**306 - 322 Richmond Street West
– Rezoning and Site Plan Applications – Final Report**

Date:	December 11, 2008
To:	Toronto and East York Community Council
From:	Acting Director, Community Planning, Toronto and East York District
Wards:	Ward 20 – Trinity-Spadina
Reference Number:	07 238270 STE 20 OZ

Attachment 2: Elevations

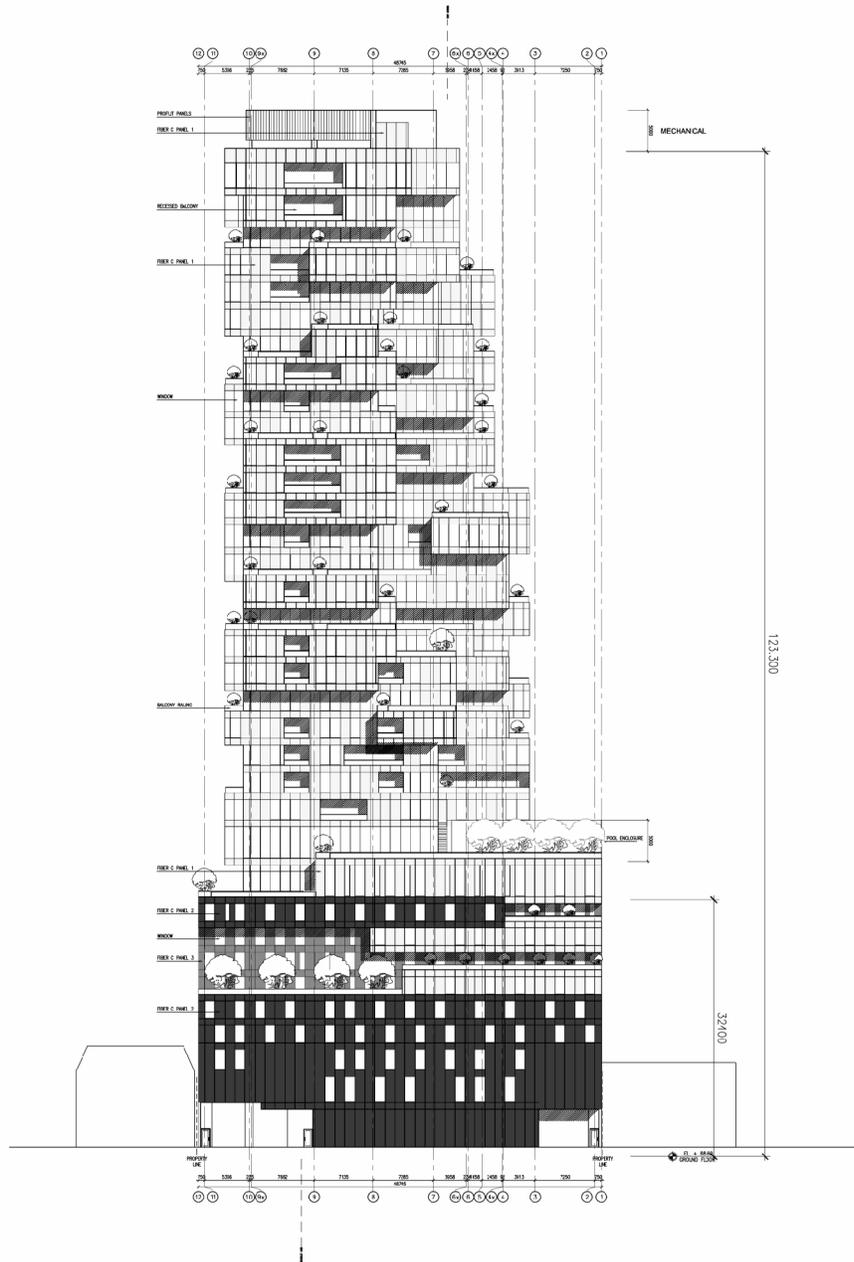
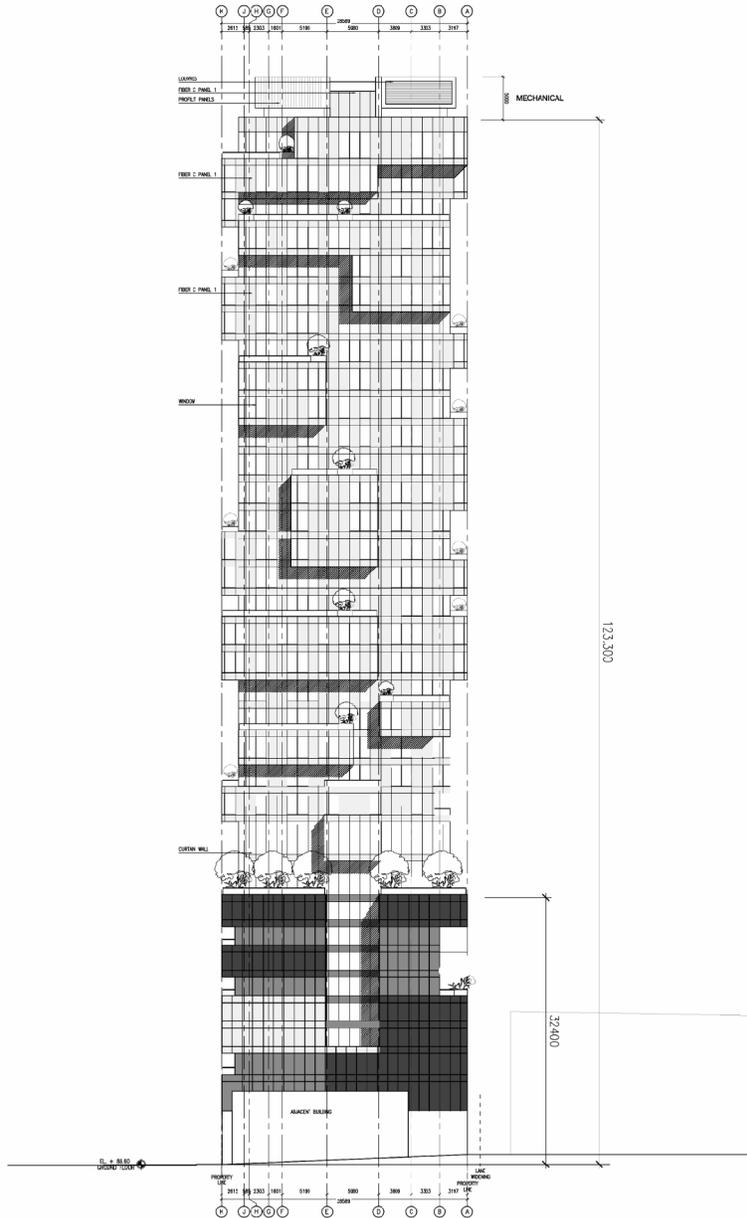
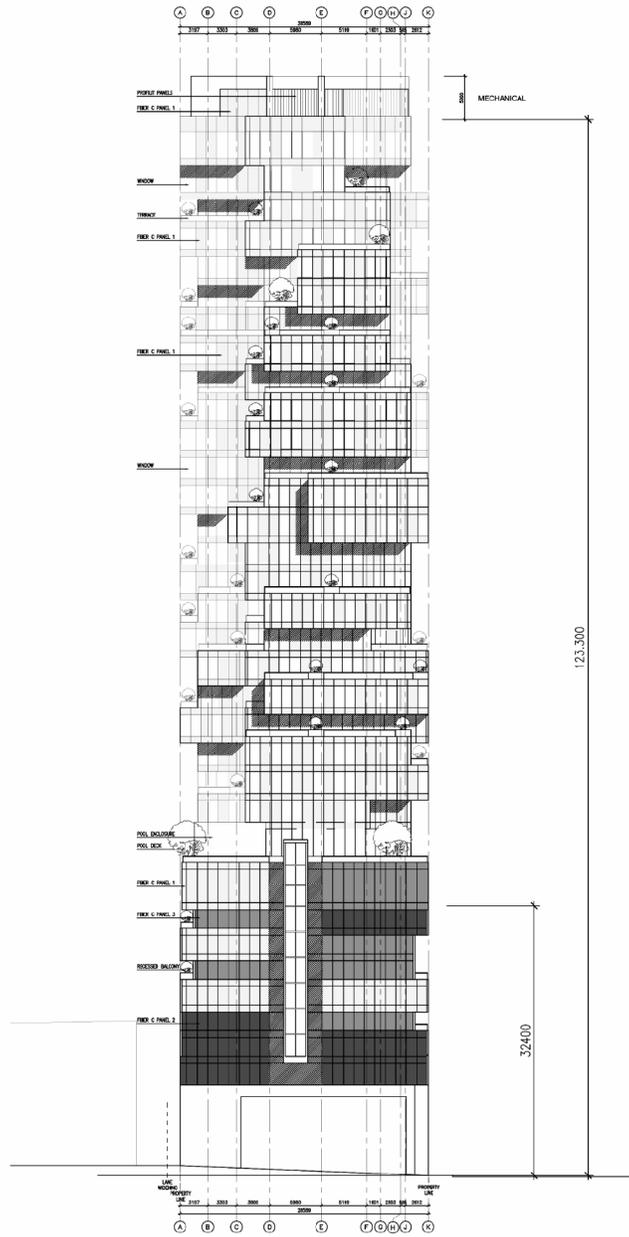
A nine storey podium is proposed at the Richmond Street West frontage. Along this frontage, the shaft or body of the tower wall plane rises from the podium with minimal discernable setback between its wall plane and that of the podium. The design scheme of the podium contains a sequence of multi-level glass curtain wall elements that are further articulated architecturally with balconies and horizontal cementitious elements. The visual effect of the podium, along the street frontage, is one in which the mass of the podium elevation plane is arranged horizontally rather than paginated into vertical rhythms that would respond to historic development patterns in the district. Also, the podium design effect is one in which glazed surfaces predominate (relative to opaque cladding) in terms of exterior surface materials proposed for use.

Secondly, the project's podium does not relate architecturally with adjacent structures or other historic buildings on the block face. At the Richmond Street West frontage, there still remains a well established pattern of individual buildings on narrow lot frontages. The podium design instead employs large horizontal surface areas of glazing with other design elements that do not break the podium elevation plane markedly.

Also, the podium cap or termination does not relate with the heights of nearby heritage structures. In effect, the project scale, height, and design scheme would effectively sever the visual integrity of this streetscape as seen from the surrounding public rights of way. Moreover, the project would fragment the historically distinctive character of the street within the East Precinct of the King Spadina Plan area.

windows. The current design of the podium building wall do not relate with the proportionate ratio of glazed to exterior surface material extant at either the adjacent inventoried resource or along the street frontage. Please change the proportion of these elements to better relate with the existing historic character. .

That a design based mitigation strategy be developed to reduce and mitigate adverse visual impact of the development on the above mentioned HCD as well as the existing heritage character of the district. This strategy can be achieved through the following design modifications:

So that the scale and shadow of the project does not adversely impact the scale and setting of existing built form and setting of the HCD, a 45 degree angular plane should be utilized from the north side of Queen Street West in order to devise an appropriate building height to mitigate impacts potentially affecting the designated HCD.
